Architectural Response to DCC LRD Opinion
SVRD-STW-XX-XX-RP-A-022004

This report comprises an Architectural response to the Planning Report on Recommended Opinion (LRD 6009/22).

Site Uses within Z15 Lands - Residential / Commercial use is subordinate

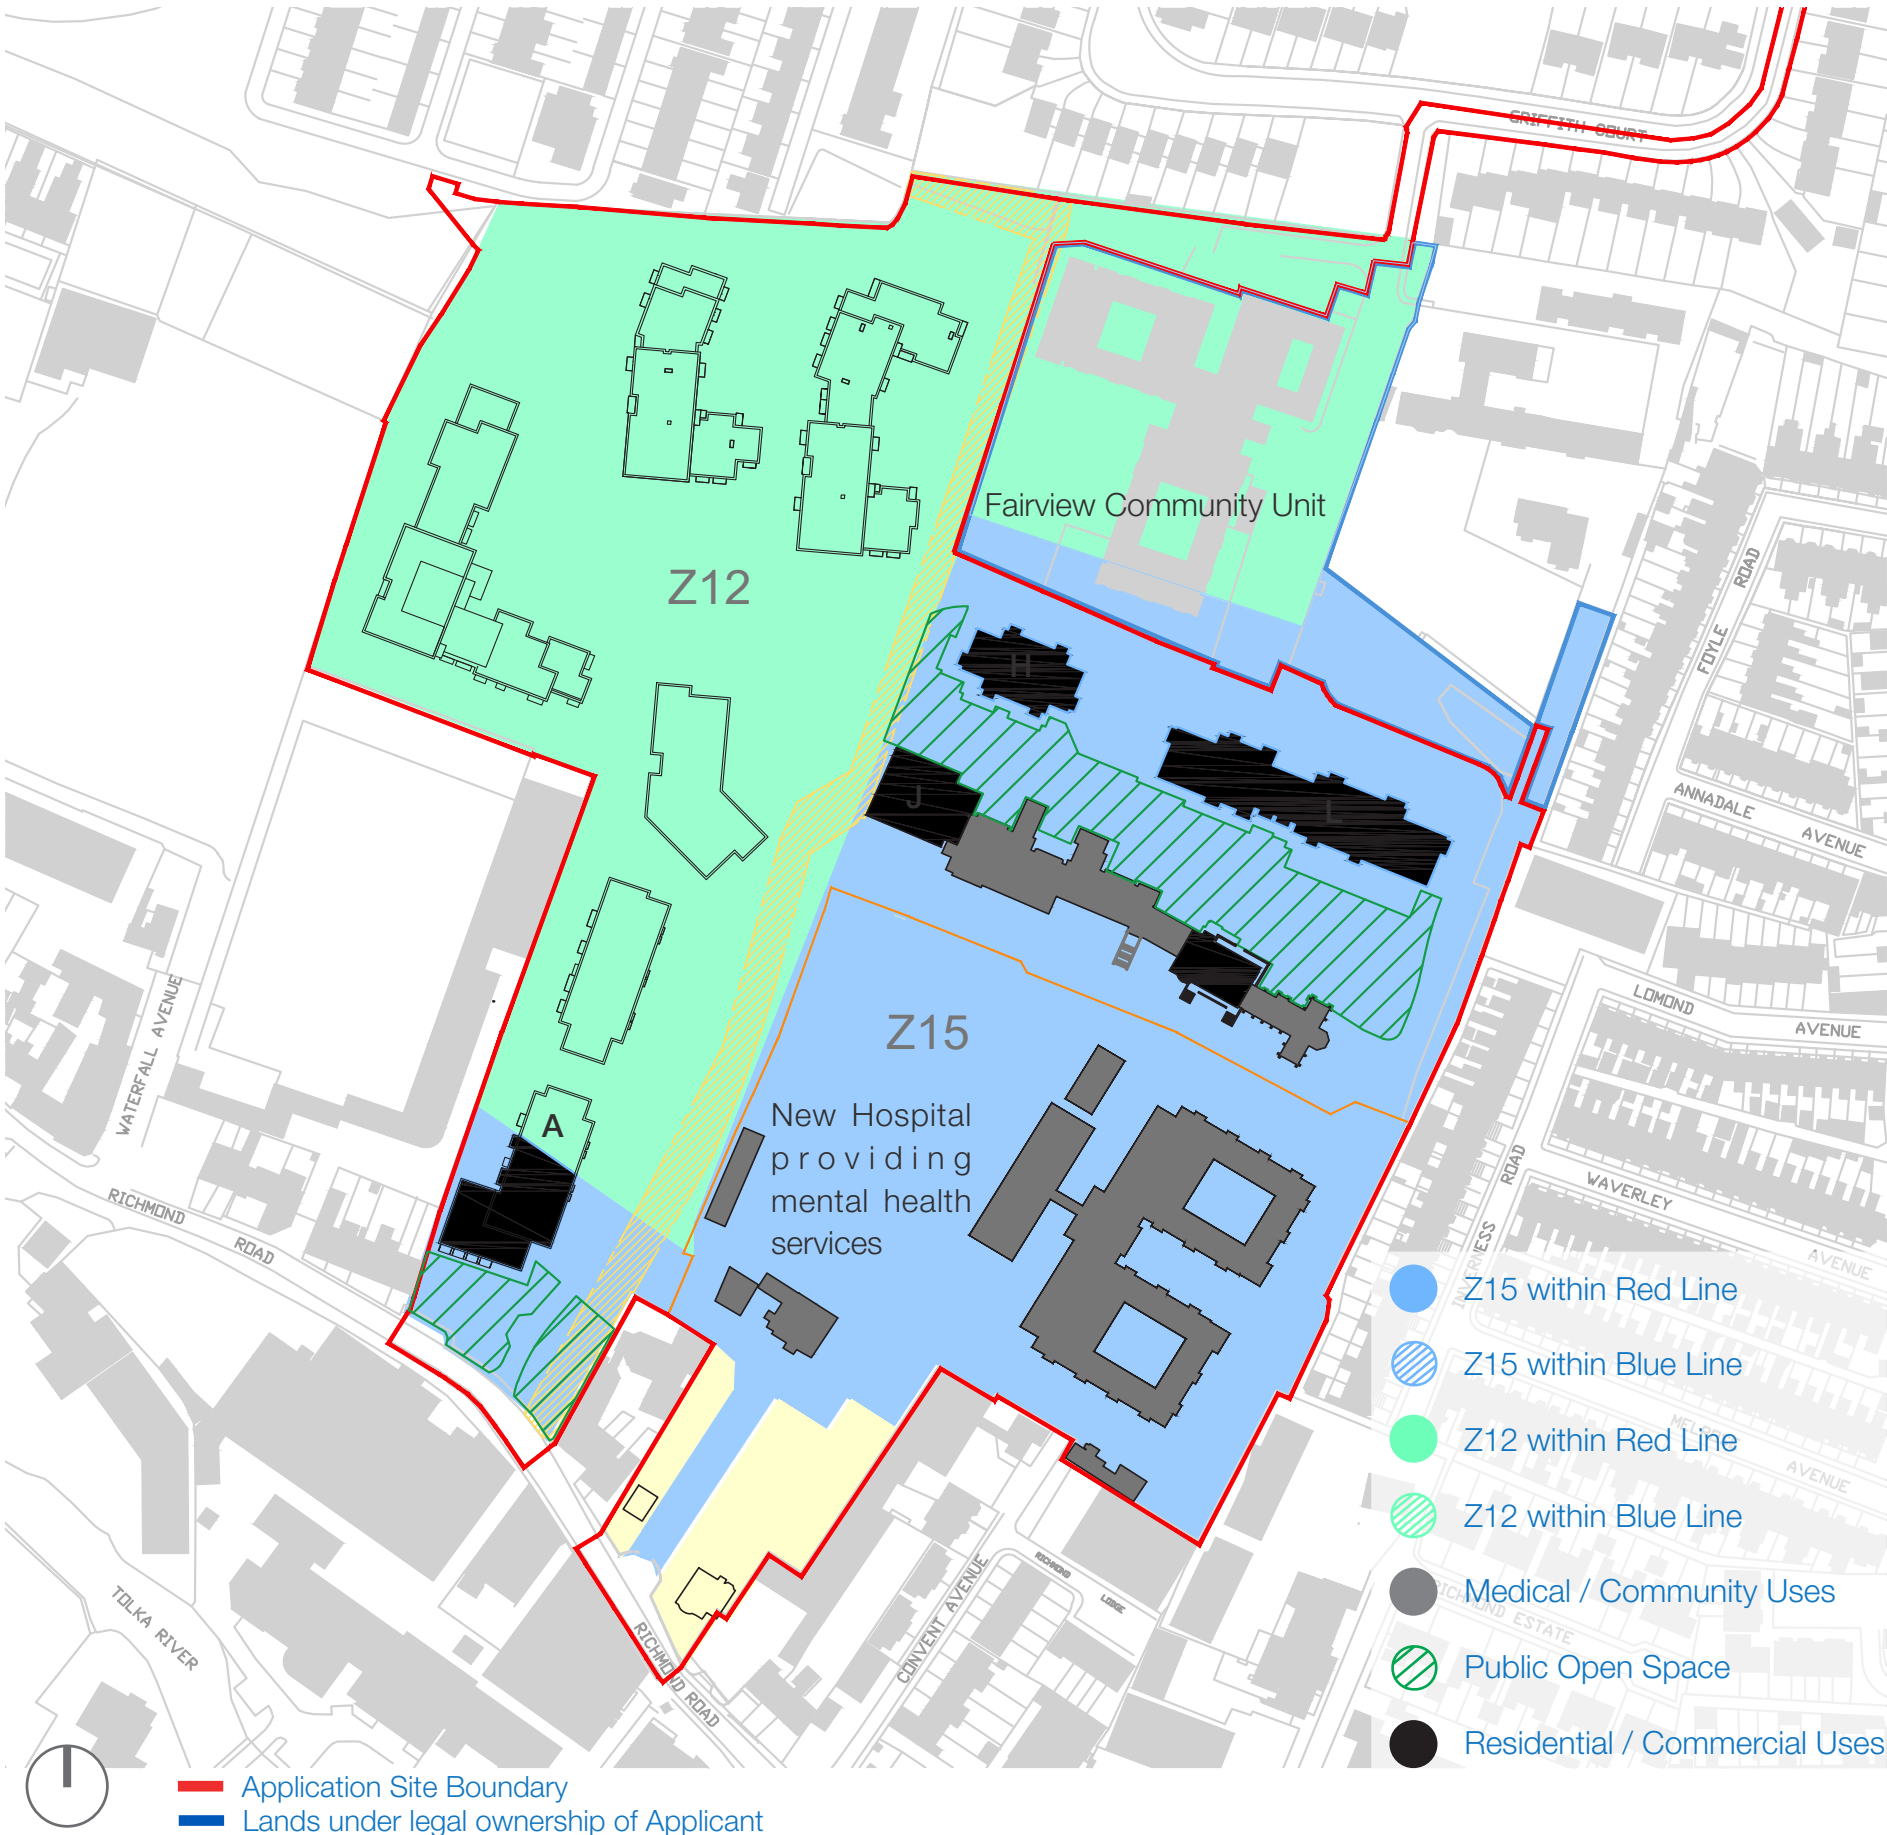
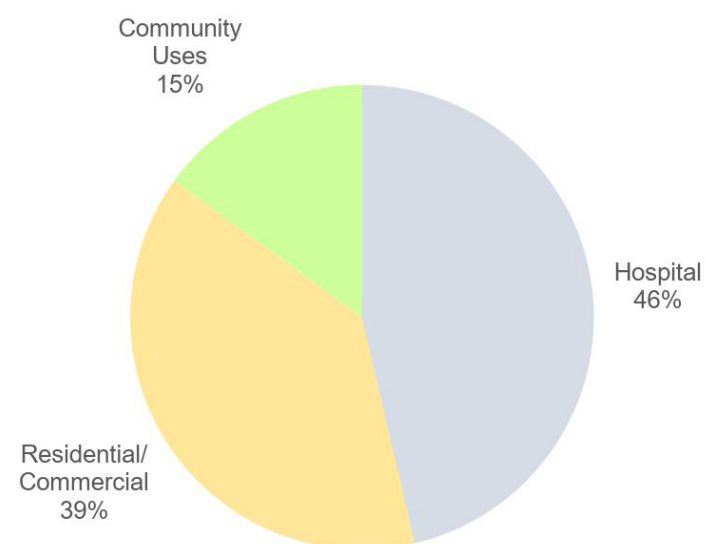
‘The applicant is requested to further outline how the development will comply with the new requirements set out for zoning objective Z15 Community and Social Infrastructure and in particular, the applicant will need to adequately justify how the proposed residential and commercial development on the Z15 lands is subordinate in scale to St Vincent’s Hospital.’

The institutional use of the Z15 lands at St. Vincent’s Hospital will remain as the primary use on the land, with the residential and commercial uses being subordinate, as illustrated below. Over 50% of the Z15 lands will remain in use as a new Hospital providing mental health services and associated grounds. The grounds provide land for potential future expansion to the immediate west of the new hospital should it be required in the longer term, although the applicant does not envisage such a scenario to arise based on the services they provide. The residential and commercial development accounts for 35% of the Z15 lands. The remaining area includes 0.655 ha of public open space and community uses. The total existing and proposed community and social infrastructure accounts for 65% of the Z15 lands.

As illustrated in the drawing on the previous page, the residential and commercial development proposed in Block A, J, K H and L with a footprint of 3,800sq.m, which are contained on the Z15 zoned portion of the overall lands, are also subordinate to the primary institutional and community uses in terms of building footprint on the Z15 zoned land. The footprint of the new Hospital providing mental health services facility is 4,556 sq.m. The proposed development includes the retention, repurposing and refurbishment of a number of structures and protected structures on the Z15 lands with a total gross floor area of 5,050 sq.m, including St. Vincent's Hospital buildings, part of which is a protected structure under RPS Ref.: 2032, Brooklawn (RPS Ref.: 8789), Richmond House (RPS Ref.: 8788), the Laundry Building, Rose Cottage and Richmond Gate Lodge. The footprint of the community uses within the refurbished hospital building is 1,475 sq.m. The area of public open space on the Z15 zoned portion of the land is c.6,400 sq.m.

Proposed Third Floor Plan & Functions

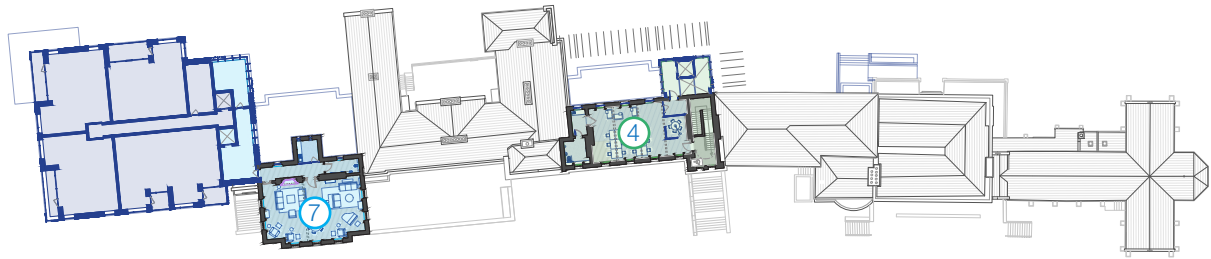
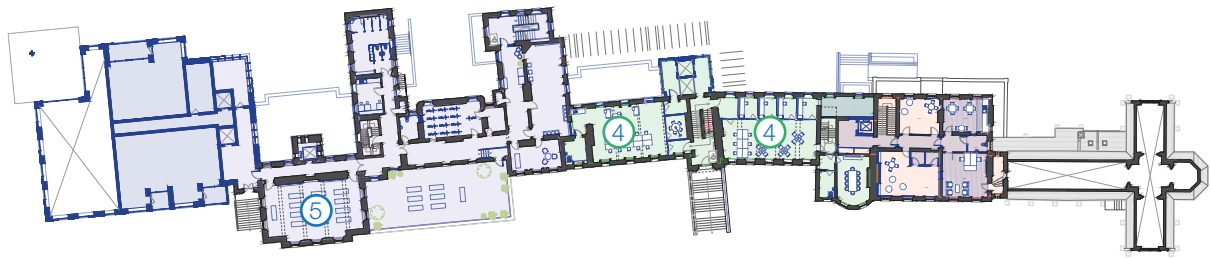
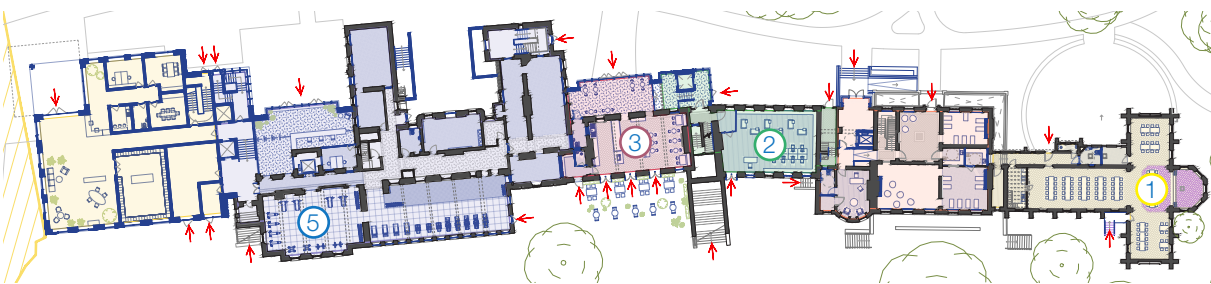
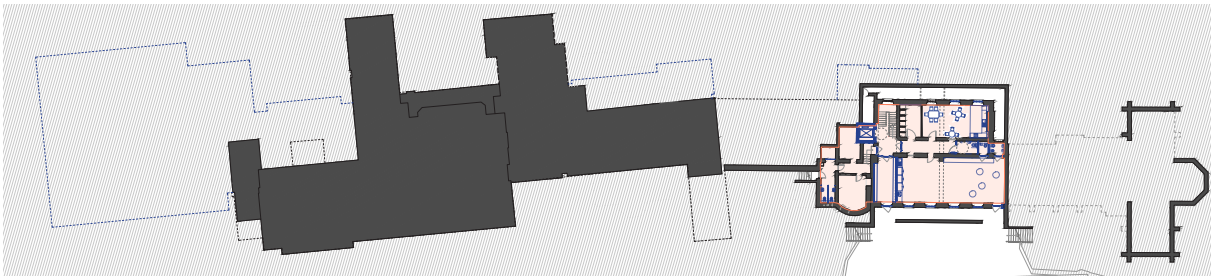
‘The Social and Community Infrastructure Audit/Assessment should include the total site in measurements. The childcare facility should not contribute to the overall provision. More weight should be given to the overall proposals within the site including the refurbishment of existing buildings and the provision of a new hospital facility that would on balance provide a wider planning gain across the site towards meeting CUO25.’

GIA for Hospital Site =	8,411 m²
GIA for Residential Site =	74,954 m²
Total GIA =	83,365m²
5% of GIA =	4,168m²

Cultural/Community	Building	Area
1	Community Hall	K4	243 m²
2	Community Library	K2	163 m²
3	Cafe	K2	160m²
4	Co-working	K2	817 m²
5	Gym	K1	1,459m²
6	New Hospital		8,411m²
Total			11,253m²

Therefore the total proposed area of 11,253 m², which includes a broad range of community uses from a Community Hall to the new Hospital providing mental health services greatly exceeds the minimum requirement of 4,168m².

East-west Site Section through Building B and the new Hospital providing mental health services (See Drawing SVRD-STW-ST-ZZ-DR-025002)

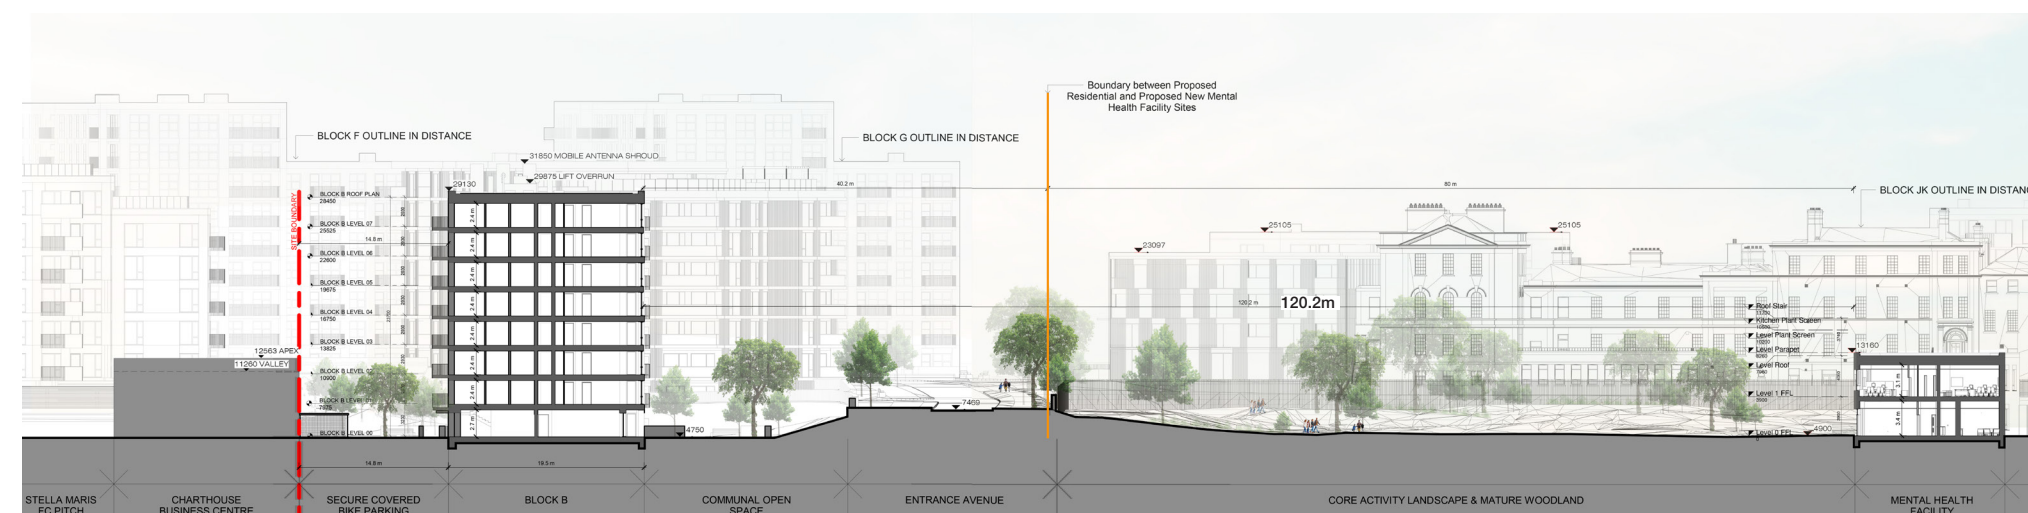
Justification for the increase in the number of storeys to Blocks A, B, C, J, the northern section of Block F and the central corner of Block DE from earlier pre application consultations with consideration given to the sensitive location of some of these blocks to existing neighbouring residential development.

Following additional analysis and design - including a series of verified views prepared by Modelworks - it was determined that additional height on A and B was justified due to:

- the distance of these buildings from the proposed new Hospital providing mental health services (approx 120m), especially given the extent of existing and proposed landscaping.

SEPARATION DISTANCES & OVERLOOKING

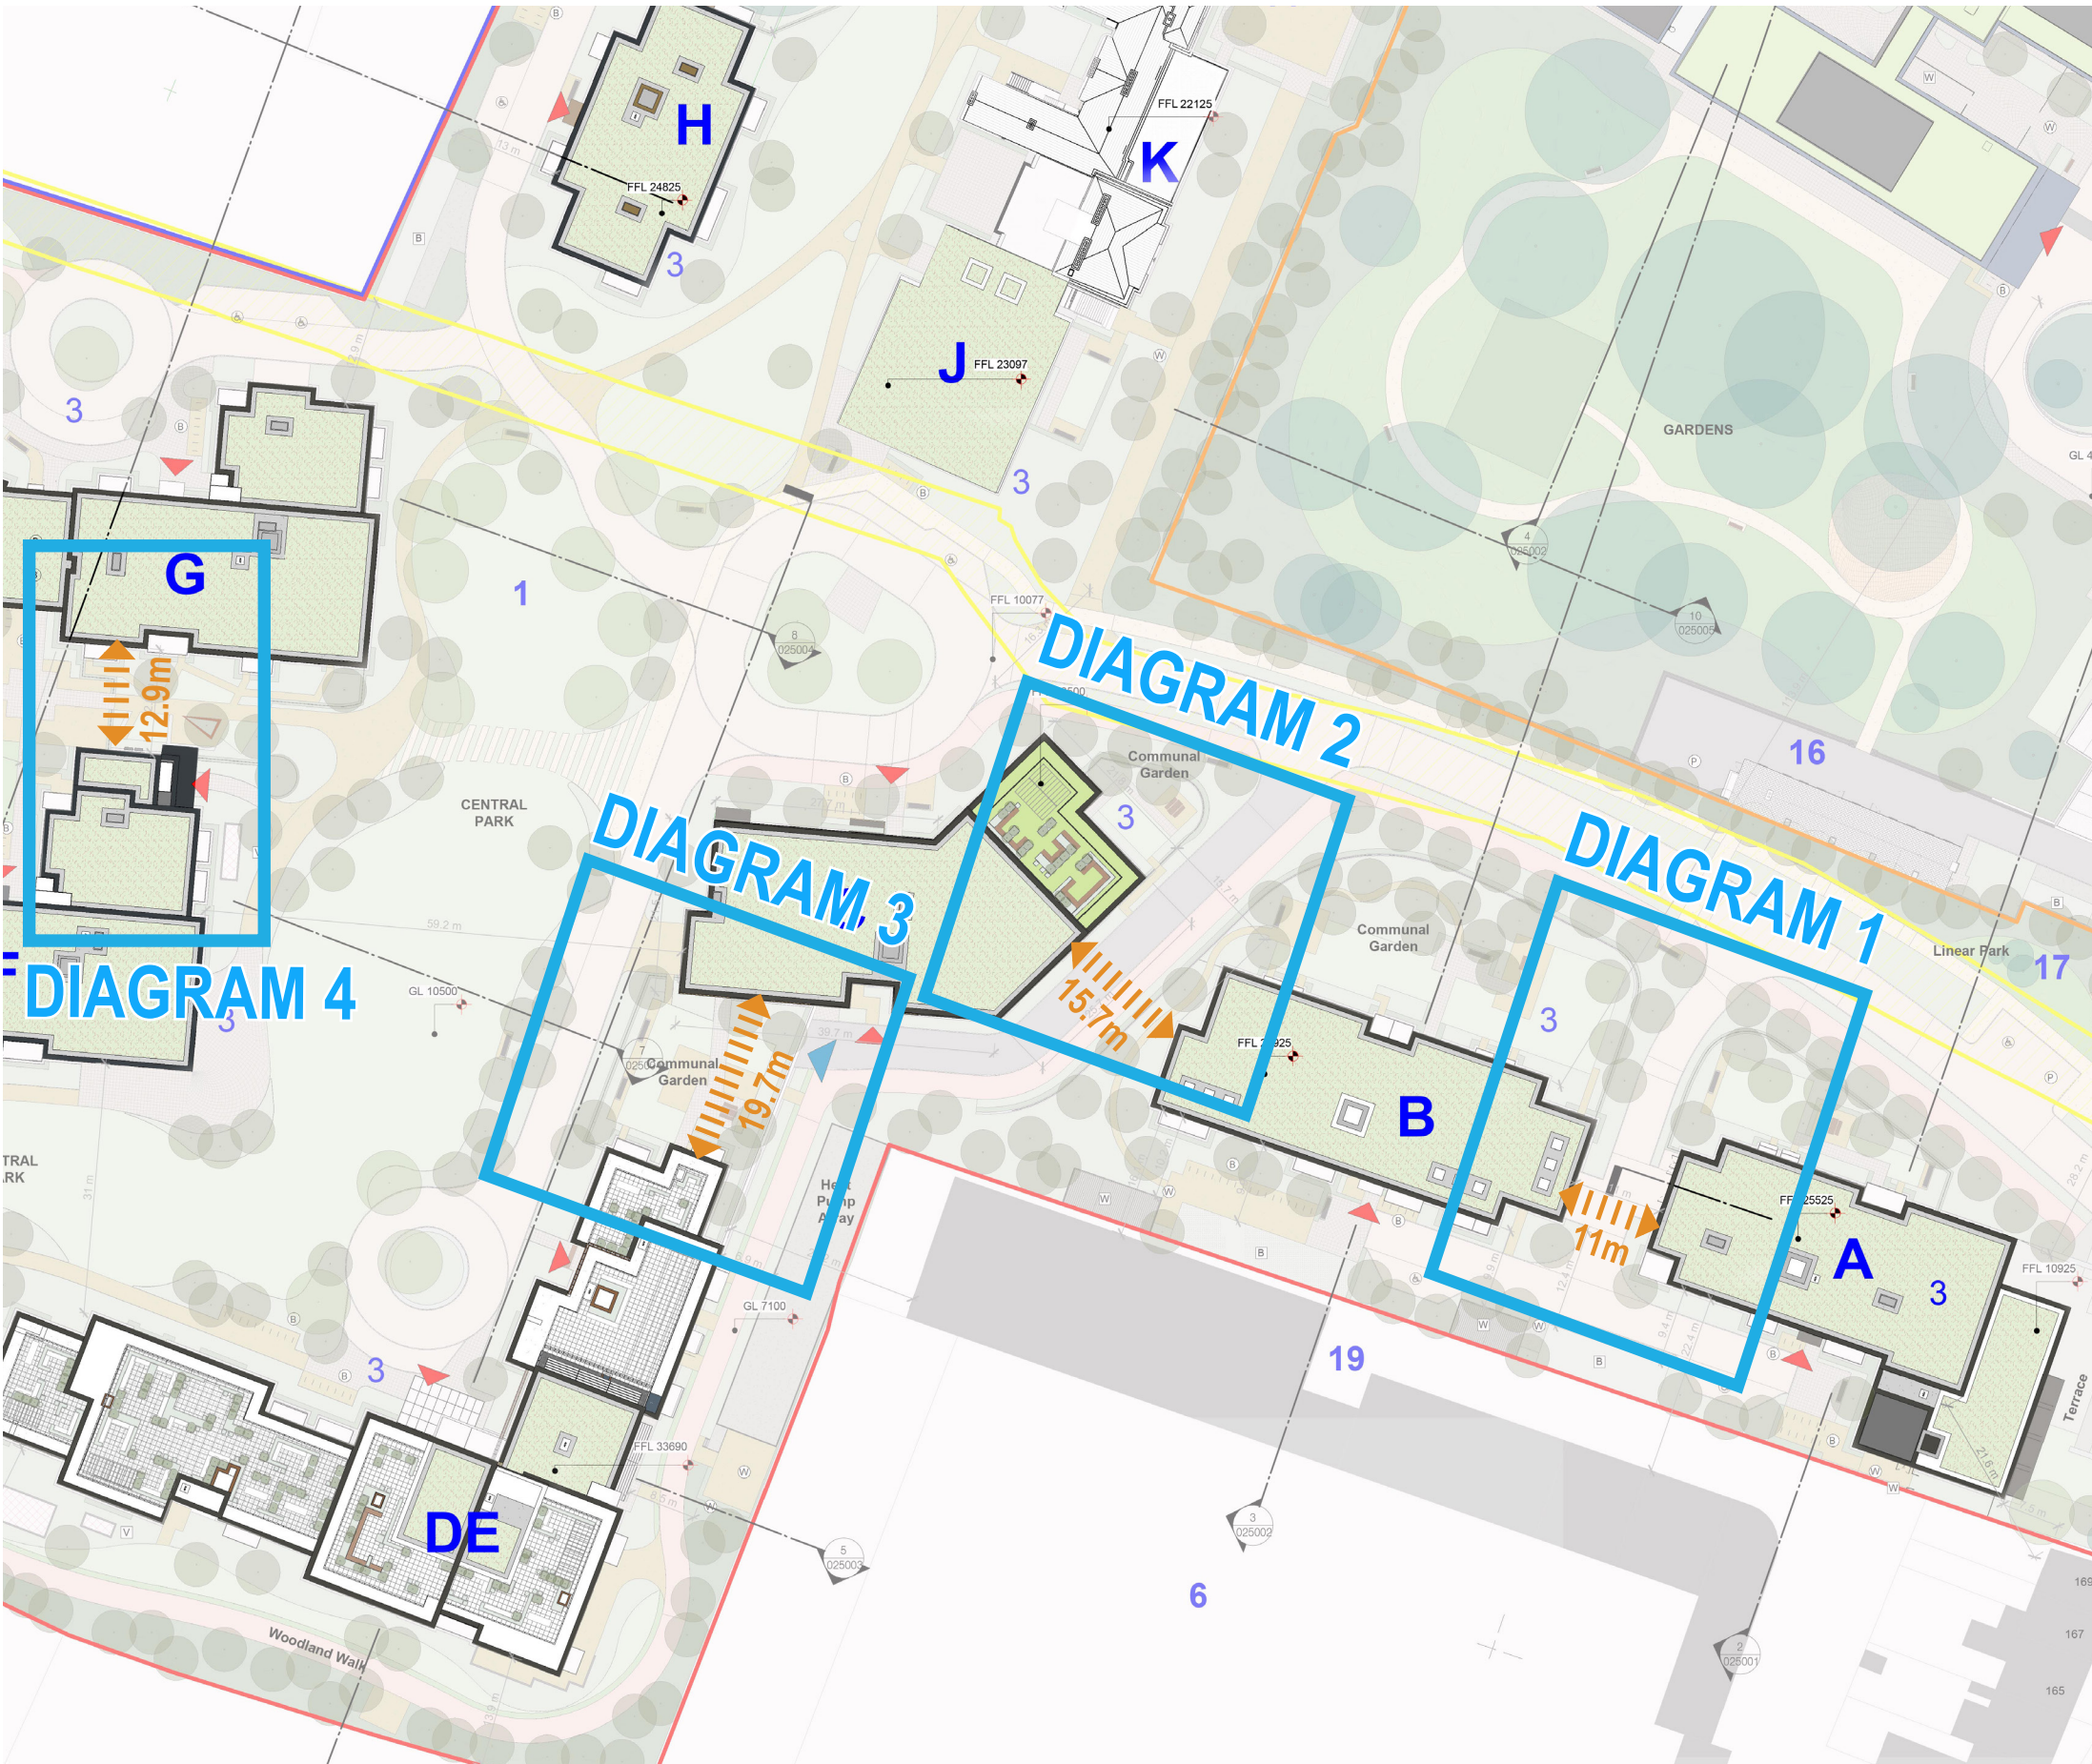
Provide a report which sets out measures to maximise future occupants' private amenity by minimising reciprocal potential overlooking between unit's balconies and window where the blocks' elevations are in close proximity to each other – such as considering applying: high screens to the sides of projecting balconies; directional overlooking treatments; opaque glazing to balconies, opaque glazing and/high level windows to unit's secondary opes (while still allowing sufficient access to daylight to best practice recommendations); mismatching directly opposing opes (hit & miss) where active windows are at close quarters with each other.

The apartment blocks generally have generous separation distances. Windows and balconies have been placed to prevent overlooking between the blocks where separation distances are smaller.

- The majority of apartment buildings are a minimum of 22m apart.
- In limited instances, depending on orientation and location in built-up areas, reduced separation distances may be acceptable. Separation distances between buildings were assessed on a case by case basis to ensure compliance with Section 15.9.17.
- Corridor and Staircase windows are non-occupied spaces. However, when these face windows across reduced distances, the glazing is frosted to further ensure the privacy of the opposing unit.
